ōLiv 50TH RESIDENCE
Seattle, Washington

GGLO
CORE Spaces
Recommendation Meeting 01
Meeting Date: Oct 23,2023

Site B - Mid-rise
SDCI Project Number : 3039651-LU
3039717-EG

SCHEME 3 / EXTERIOR REVEALS

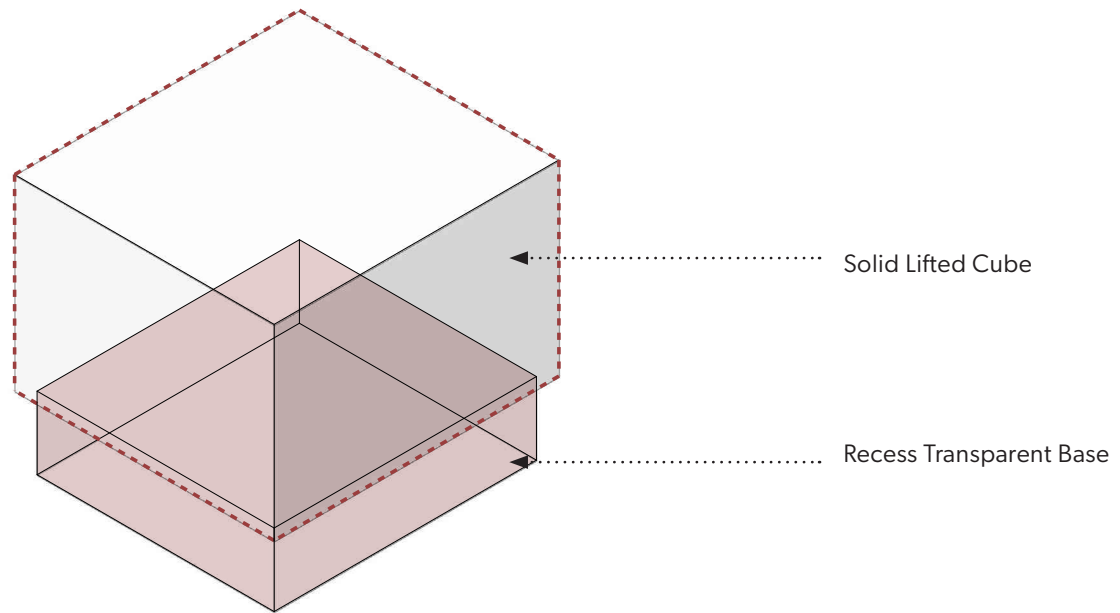
A - The Board unanimously supported massing Scheme 3, the applicant’s preferred massing option. The Board commented that the massing options shown in the EDG packet represented façade treatment approaches, not massing variations. The Board acknowledged, however, that proposing major massing moves on a relatively small site like this one is often difficult, and they were satisfied that the three distinct facade options gave enough variation for consideration at EDG. The Board noted that Option 3 used material application to emphasize the ground level commercial use, differentiate the location of the residential entry, and to visually break up the upper level masses.

- Position of rooftop mechanical screen maximizes light and views to adjacent tower
- Clear delineation of residential and commercial spaces
- Reveals and vertical massings are reminiscent of language found in adjacent proposed tower
- Corner masses emphasizes the intersection of Brooklyn and 50th

NE 50th ST Facade (North)

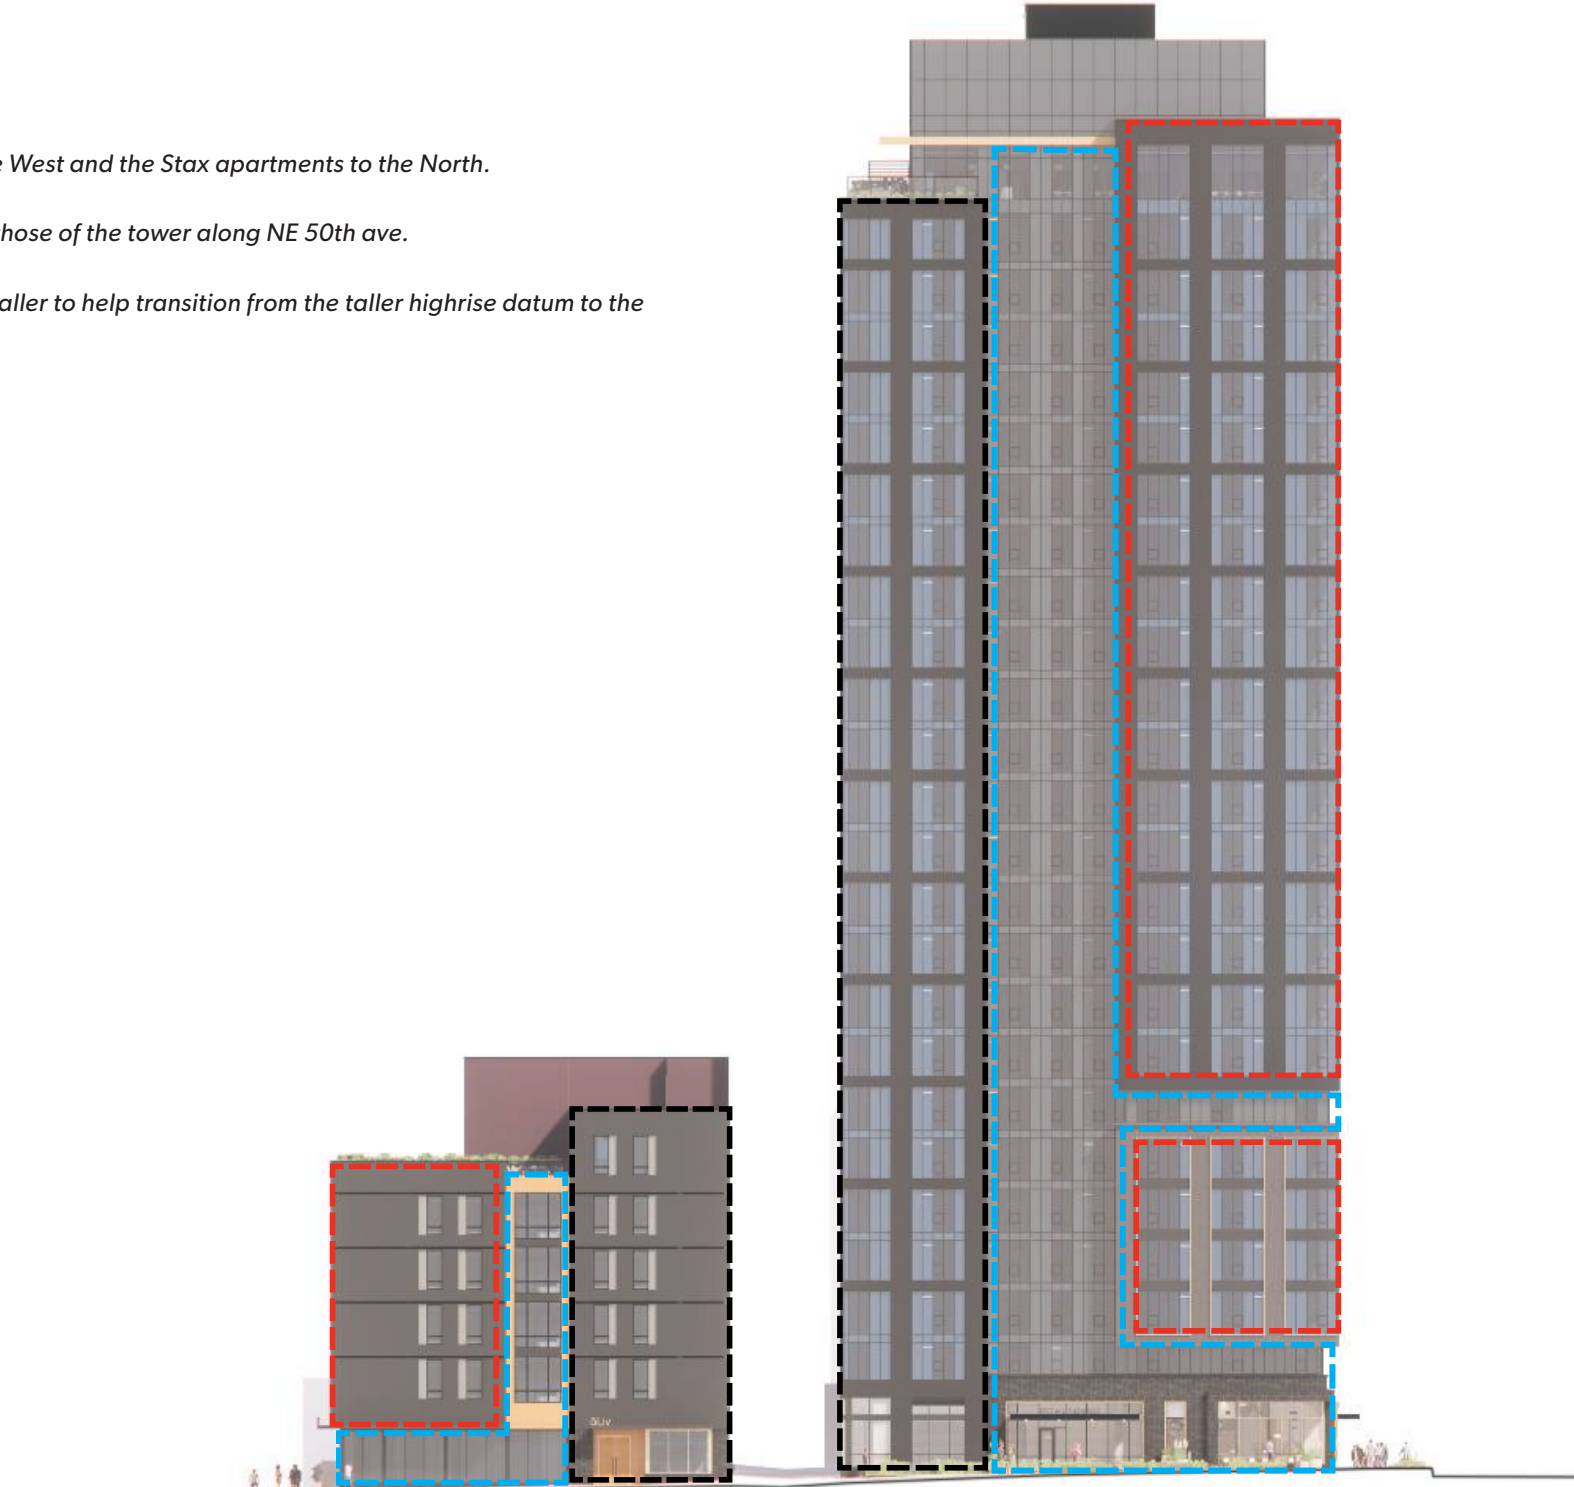
C - The Board noted that this corner site was also ‘peninsular’, with visible frontages along the two street frontages as well as the proposed open space to the south. They agreed that the façade design approaches in the EDG packet responded to these edges and appeared well developed. They gave guidance to demonstrate at the Recommendation phase how the design has been developed with equal consideration of the three visible façades.

The adjacencies along 50th street are the site A tower to the West and the Stax apartments to the North.

- Massing moves in midrise building conceptually mirror those of the tower along NE 50th ave.
- Residential entrance tower mass on midrise building is taller to help transition from the taller highrise datum to the locale midrise datum

Proposed Ground Floor Diagram

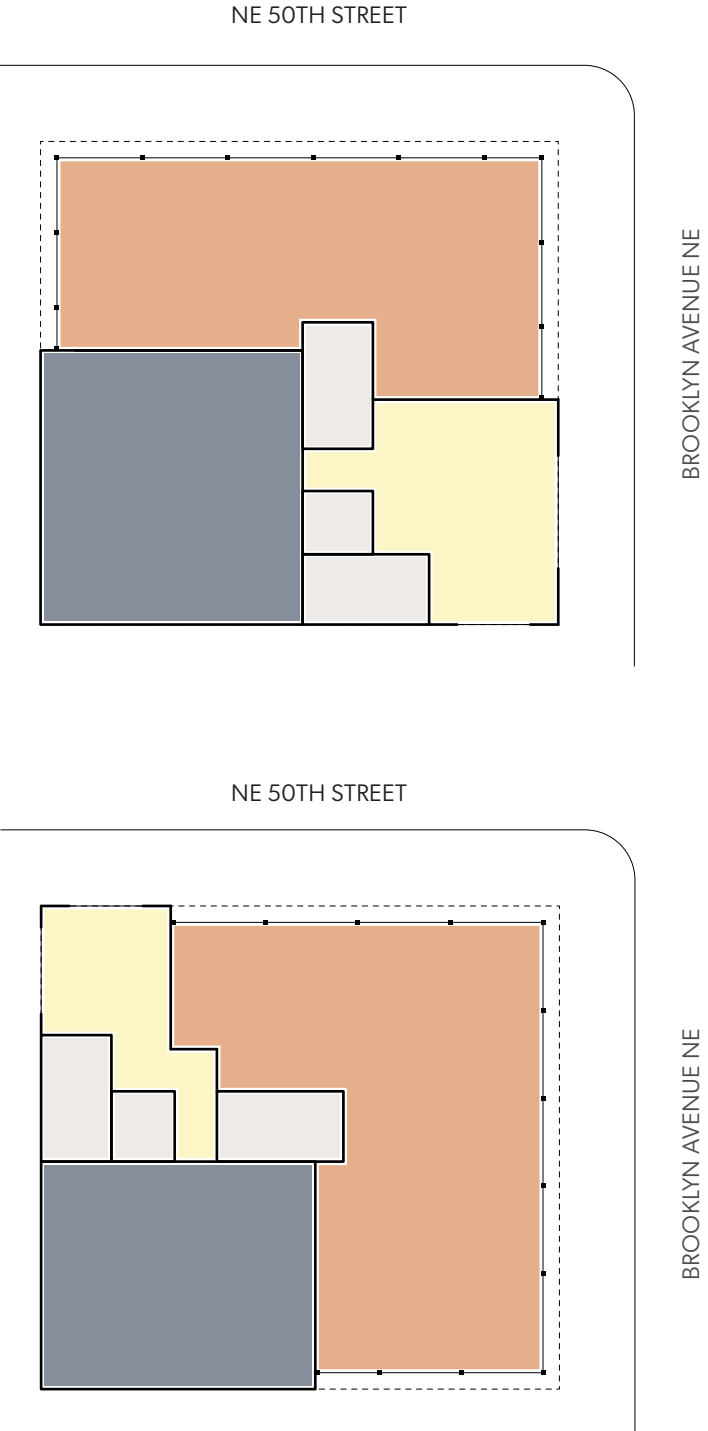
A - The Board noted that the interior floor plans of the ground level and upper levels were the same on all three massing options, which limited opportunities to create distinct design options for orientation of the building to the site. The Board commented that they assumed the design team worked through layout options, but it would have been helpful for the Board to see what the applicant considered the ‘unsuccessful’ layouts to understand why only one plan option was presented. The applicant noted that the commercial/restaurant tenant desired a visual connection to the open space which is why the commercial space is oriented towards Brooklyn Ave instead of NE 50th St. The applicant also noted the residential entry was placed on NE 50th St to be convenient to the high-rise tenant’s entrance on 12th Ave NE as the buildings will share management. The Board ultimately agreed they were comfortable with the limited site and building plan options related to having only one ground floor layout.

The commercial space saddles NE 50th street and the park to provide visual connection between open space across from NE50th ave and adjacent to the south

Other potential layouts place the residential entry at SE corner which lacks the proximity to tower lobby. Commercial would not be adjacent to the open space.

A Condition at Resident entry along 50th.

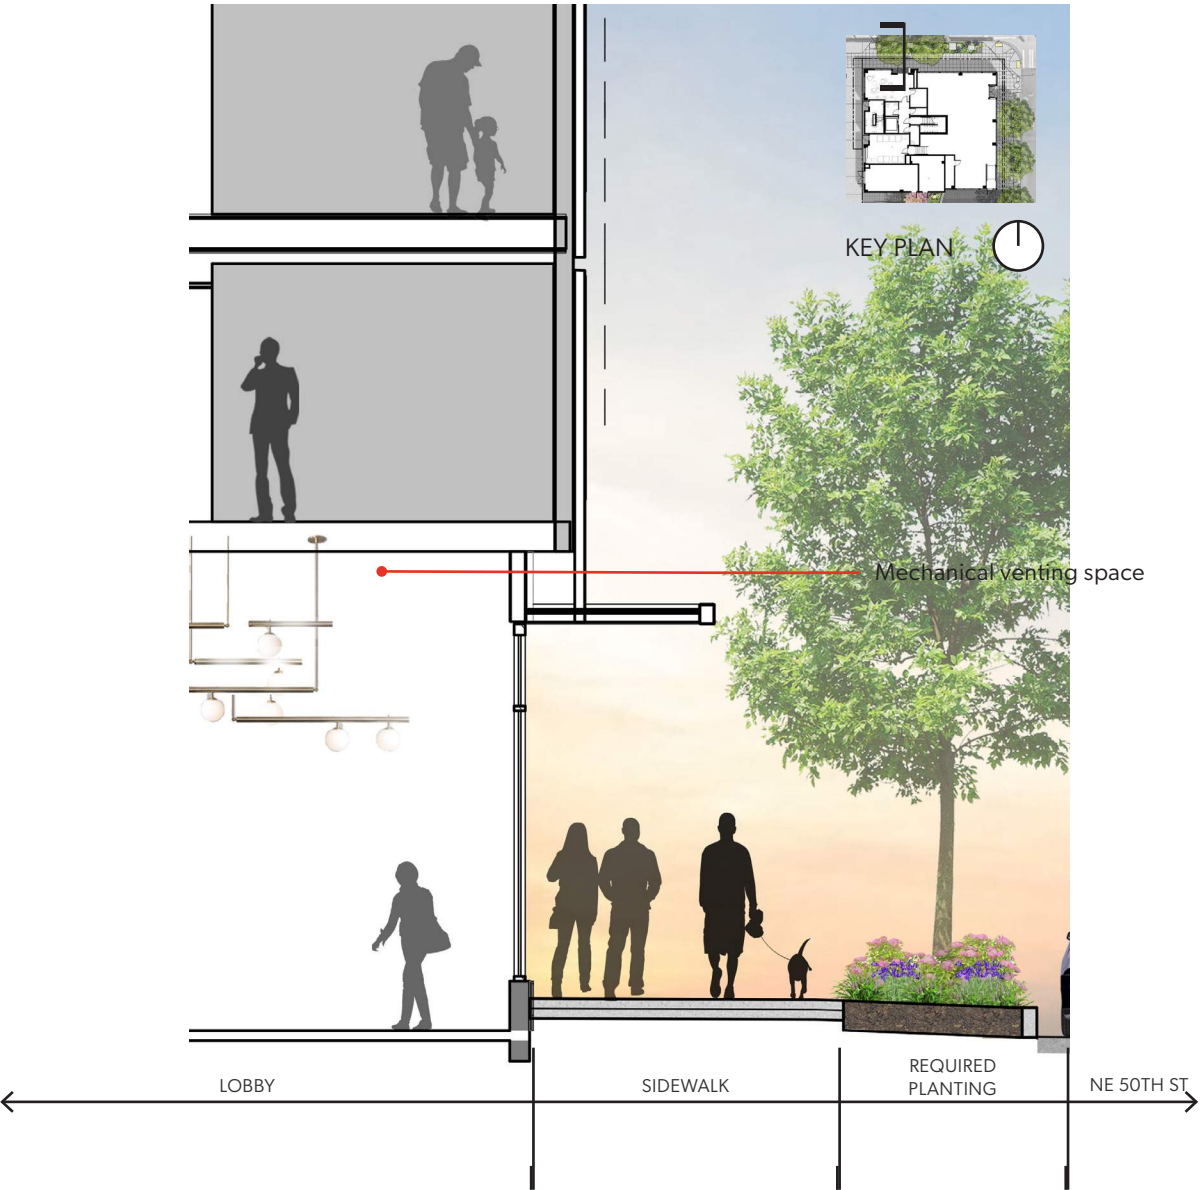
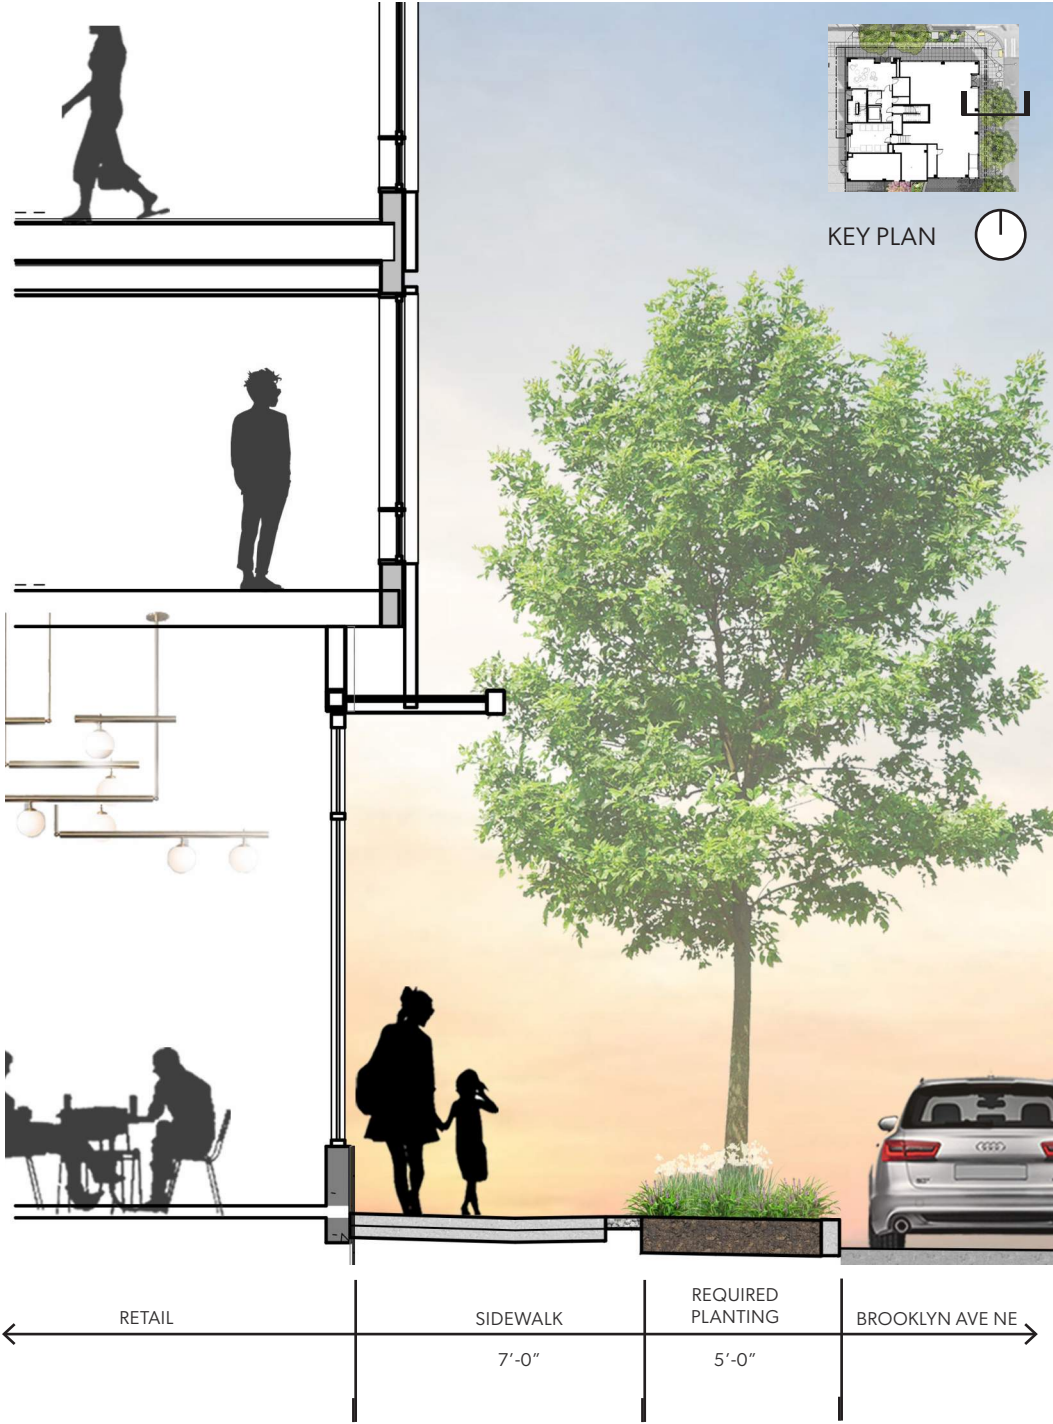
B - The Board supported the setback of the building façade at the commercial unit that will create a larger sidewalk environment at the corner of the site along both street frontages and can potentially provide spill out space for the restaurant use.

The ground floor recess, while not deep enough to provide spillout space for the retail, they allow our building to meet SDOT sidewalk requirements and facilitate a more walkable experience around the building.

Midrise Residential Entrance

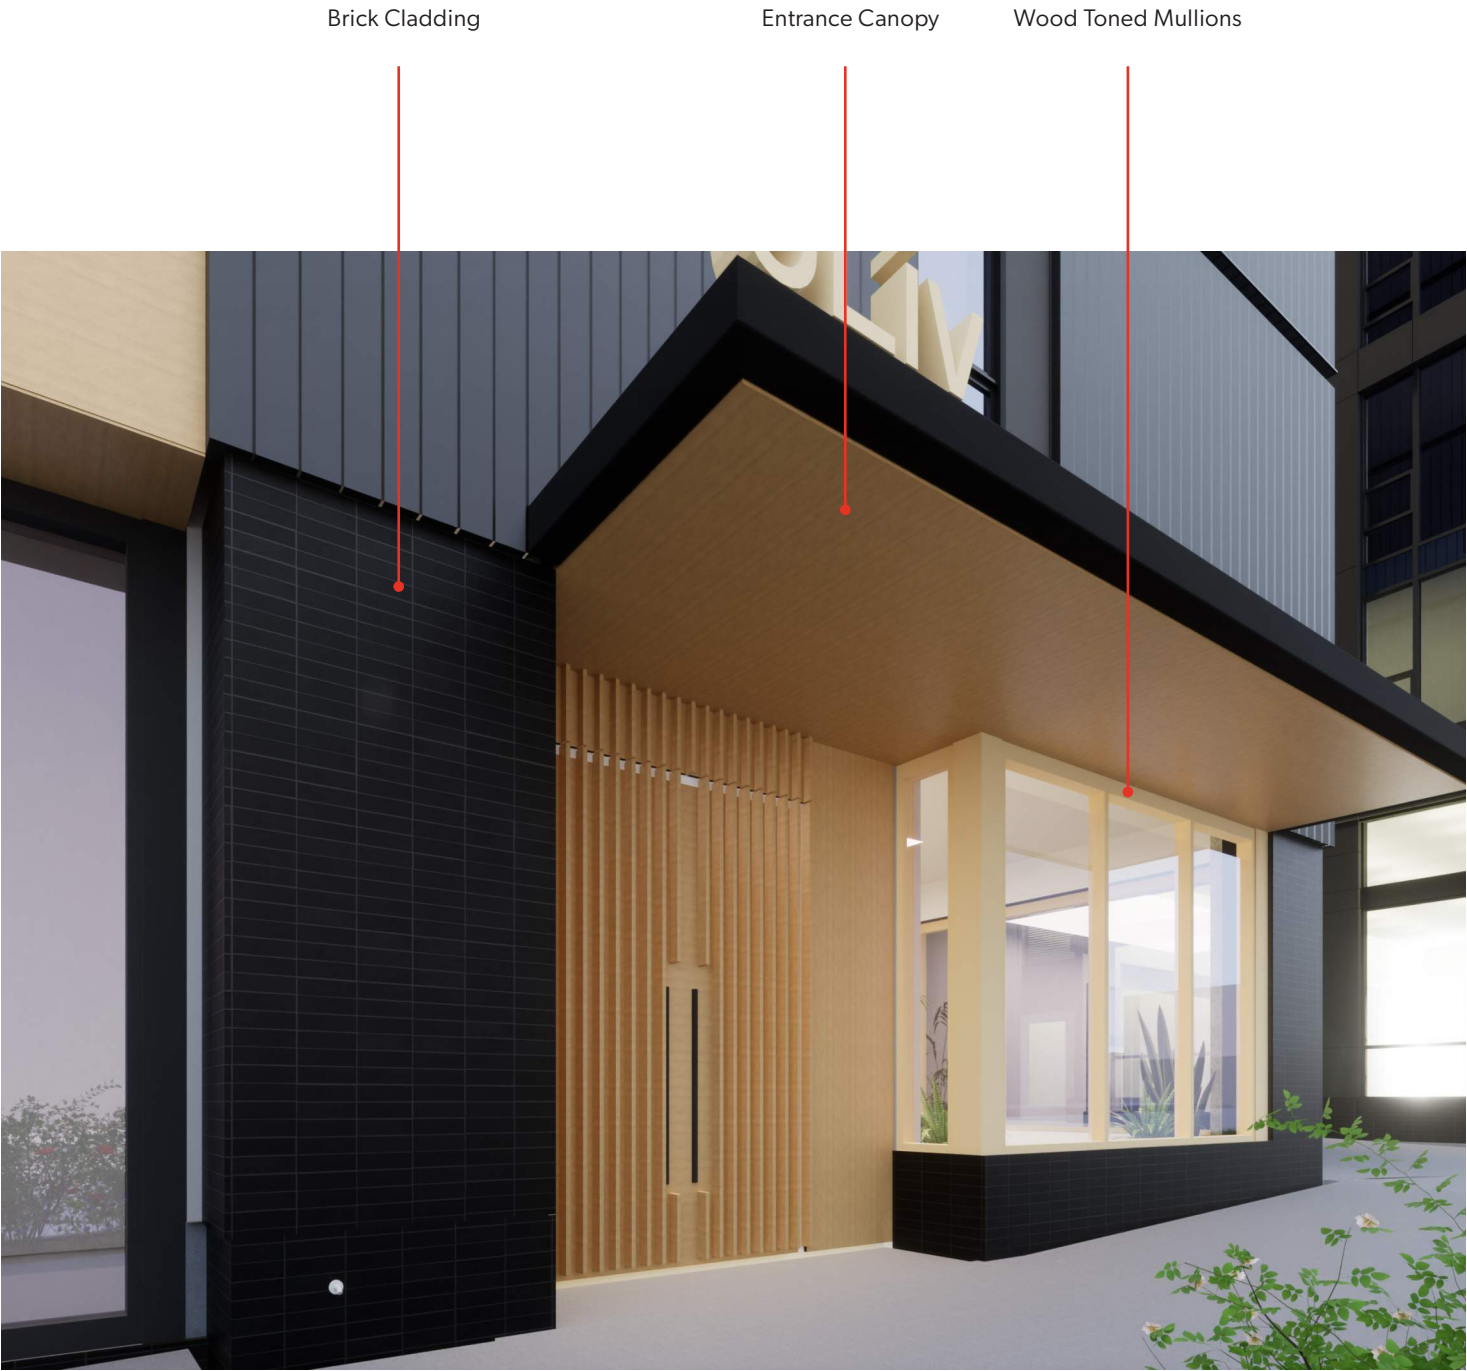
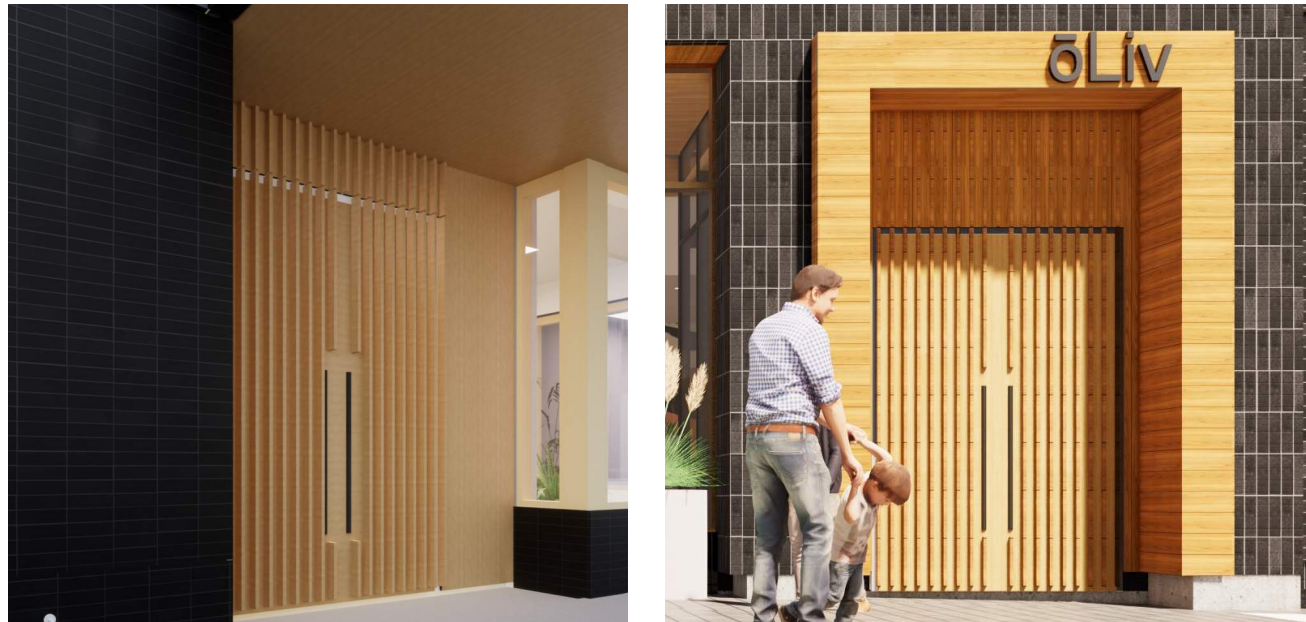
C - The Board noted that design of primary residential entrances should be included in the mid-rise context analysis and studies (requested in 1.b) to support design development concept of the residential entrance for this project.

- Midrise residential entrance storefront borrows existing U-District wood toned mullion.
- Midrise recesses the residential entry, revealing a wood toned soffit.
- The entrance canopy is recessed for a deeper canopy in front of the entrance
